Allnorth Information		VICTORIA GOLD CORP.	
Project #:	2202179	Client Project #:	
Document #:	221207	Client Document #:	
Document Rev. #:	1	Client Doc. Rev.#:	
Prepared By:	Spencer Bergin, EIT	Client Contact:	Reanna Roberts
Reviewed By:	Don Williams, P.Eng.

Annual Physical Stability Assessment Report – Victoria Gold – Eagle Gold Project

Visual inspection of the following structures: Open Pit, Platinum Gulch Dump, Eagle Pup Dump, Lower Dublin South (Control) Pond, Primary Crusher, Secondary & Tertiary Crushers, Secondary Stockpile, Adsorption, Desorption and Recovery (ADR) Plant, Heap Leach Facility, Heap Leach Overburden Stockpile, Event Pond, Emergency Pond, Ditches A, B, and C, Heavy Duty Truck Shop, Warehouse Pad, Water Treatment Plant, Orica Laydown, Various Un-named Stockpiles.

**Figure 2: LDSP – Erosion on the Southwest slope 2020**

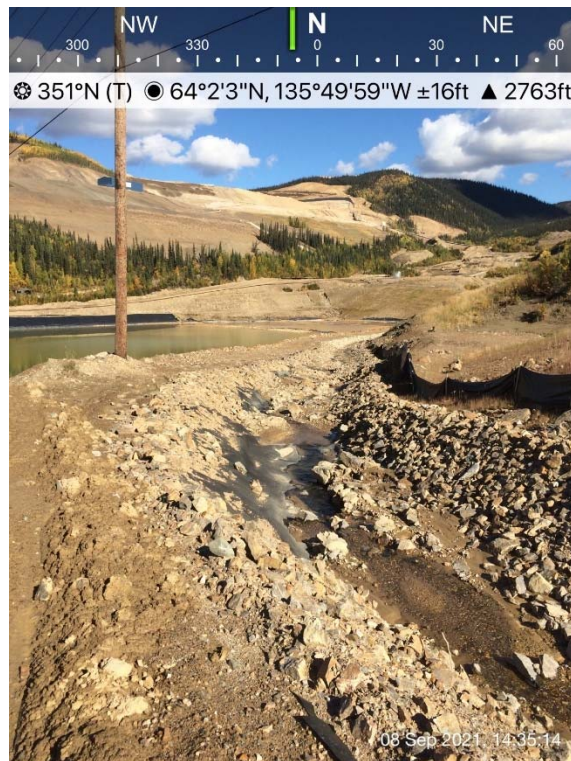
1. Some saturated material and erosion was noted on the slope of the southwest corner of the Control Pond over the width of the narrow access road in 2019 and 2020 (Figure 2,) but this erosion was rectified with the completion of Ditch A between the 2020 and 2021 inspections (Figure 3). The area is showing signs of cracking as of the 2022 inspection (Figure 4).

1. Monitor cut slopes above Ditch A for further erosion, sloughing and cracking.

**Figure 6: LDSP – Some flow from adjacent culvert 2020**

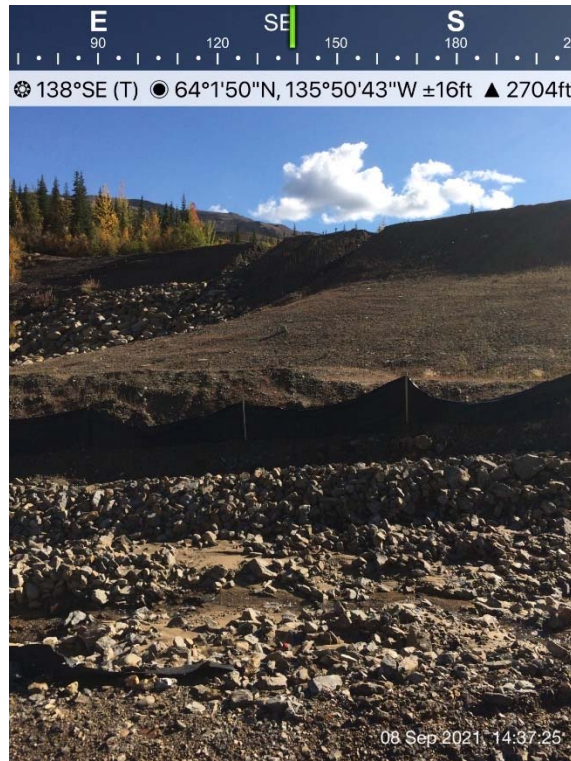
2. There was some flow into Ditch A on the Southwest corner of the LDSP from a culvert crossing a former construction access road, which was observed in 2019, 2020 and 2021 (Figure 5, Figure 6, Figure 7) and still present as of this inspection (Figure 8). Liner was installed under the culvert outlet at the time of this inspection to alleviate erosion (Figure 8).

**Figure 12: Perimeter Ditching 2020**

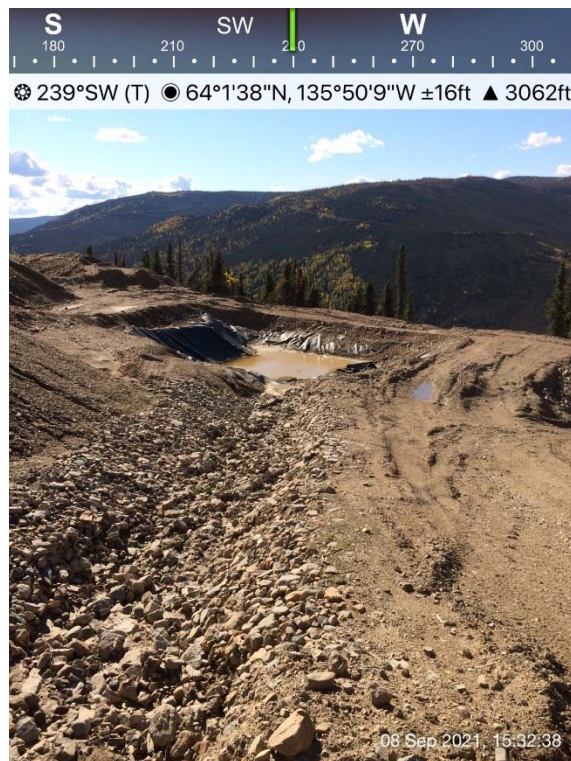
1. A perimeter interception ditch extends around the downhill toe of the Secondary Stockpile area. The construction of this ditch was not complete in 2020 but has since had rock armoring installed (Figure 12, Figure 13). Issues noted in the 2020 inspection including over-steepened and sloughing slopes on the interception ditch appear to have since been addressed. The ditch appears in good condition as of this years inspection (Figure 14).

1. Monitor over-steepened slopes, cordon off if accessible by site staff.
2. Tie the perimeter ditch into the collection sump.

**Figure 18: Heap Leach Facility Overview 2019**

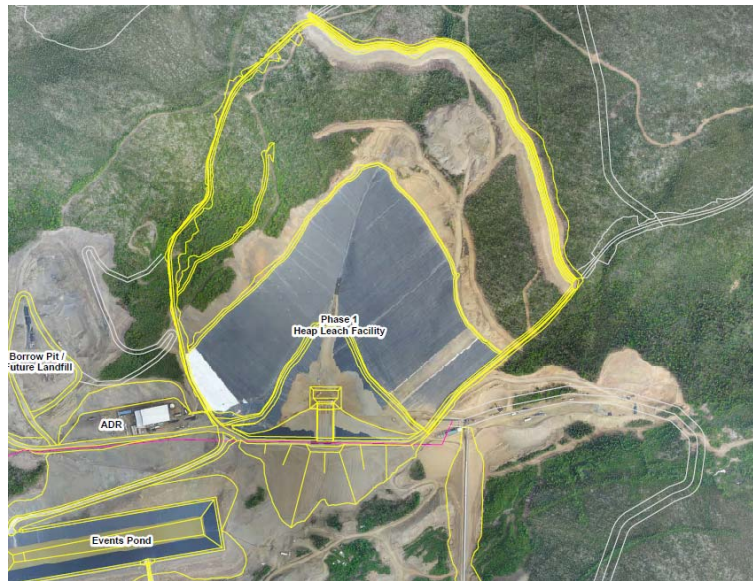
1. The Heap Leach Facility (HLF) is currently operational. In 2019 the Phase 1A expansion had been constructed as shown in Figure 18. By the time of the 2020 inspection the Phase 1B expansion was largely complete as shown in Figure 19. During the 2021 inspection land was being cleared and graded for the Phase 2 expansion as shown in Figure 20, and for the 2022 inspection liner was installed on part of the cleared area (Figure 21).

**Figure 22: Scouring and rilling along toe slope of HLF (2020)**

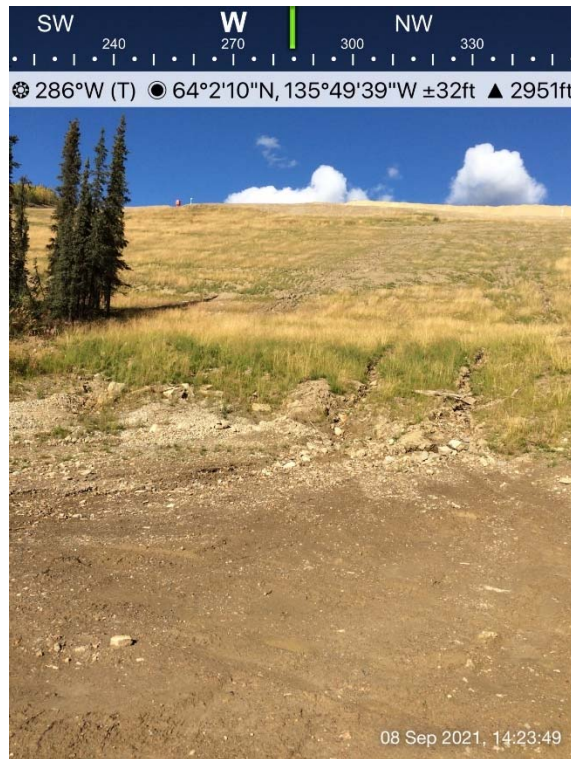
1. Some scouring and rilling was noted along the toe slope below the HLF and above the unnamed stockpile area and HLF Underdrain Monitoring Vault in the 2020 inspection (Figure 22). The slope has since been seeded and there appears to be less scouring of material off the toe slope as inspected in 2021 (Figure 23) and 2022 (Figure 24).

1. Continue to monitor the toe slope below the HLF for rill erosion.
2. Check HLF Interception Ditch and monitor sediment collection. Clear sediment collection at culverts.

**Figure 39: Platinum Gulch Dump Water Pooling**

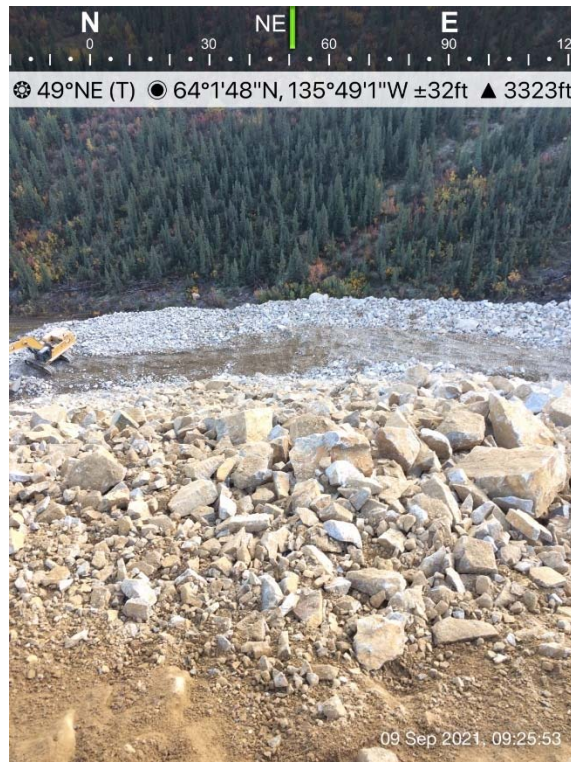
2. Some sections of pooling water and cracking were noted on the first level of the dump (Figure 39, Figure 40).

1. Monitor pooled water and cracking on first bench.

**Figure 49: Cut slopes above Secondary/Tertiary Crusher 2021**

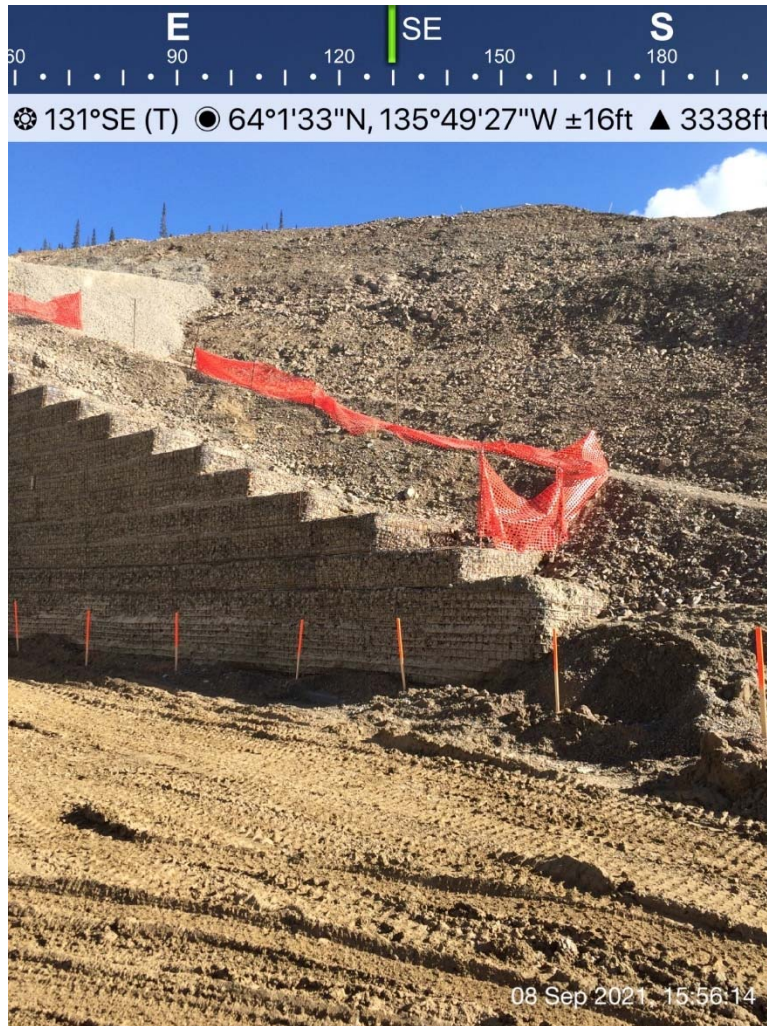
1. There has been an accumulation of fine sediment on the South slope above the MSE wall, likely from dust coming off the crusher transfer conveyor. Photos taken during the 2021 inspection (Figure 49) show a relatively clear slope, photos taken during the 2022 inspection show the silt build-up since the previous inspection (Figure 50, Figure 51).

1. Continue to develop the monitoring program currently in place for the MSE walls.
  - a. Note, VGC has instituted a monitoring program since the 2022 inspection (evidence conveyed from site via email) including regular prism scanning and review of data on the MSE walls. These programs should be continued with VGC outlining monitoring program protocols in standardized documents, and with all data saved for review.
2. Monitor sediment build-up above the MSE wall.

**Figure 56: Pooling water above Event Pond 2022**

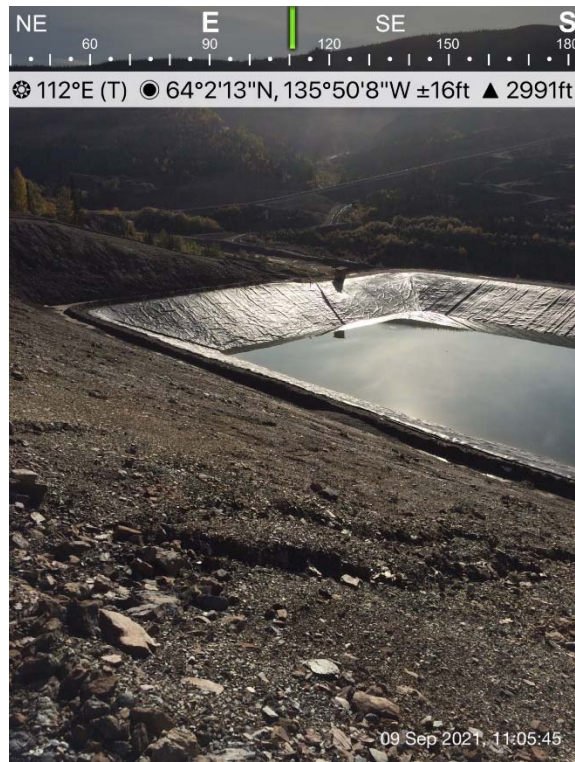
1. Pooling water appeared to be forming above the North-East corner of the Event Pond at the time of this inspection (Figure 56). Pooling water had also been noted in this location on the 2021 and 2020 inspections (Figure 57, Figure 58).

1. Monitor minor erosion of cut slopes and maintain as required.
2. Monitor pooling water above the North side of the Event Pond and regrade area to prevent pool formation or install a water handling system (sump pumps, etc.).
3. Monitor material deposits on HLF spillway and Event Pond to ensure the spillway and pond designs are not compromised through either blockage of flow or reduced pond capacity.
4. Repair excavator damage to HLF spillway liner.
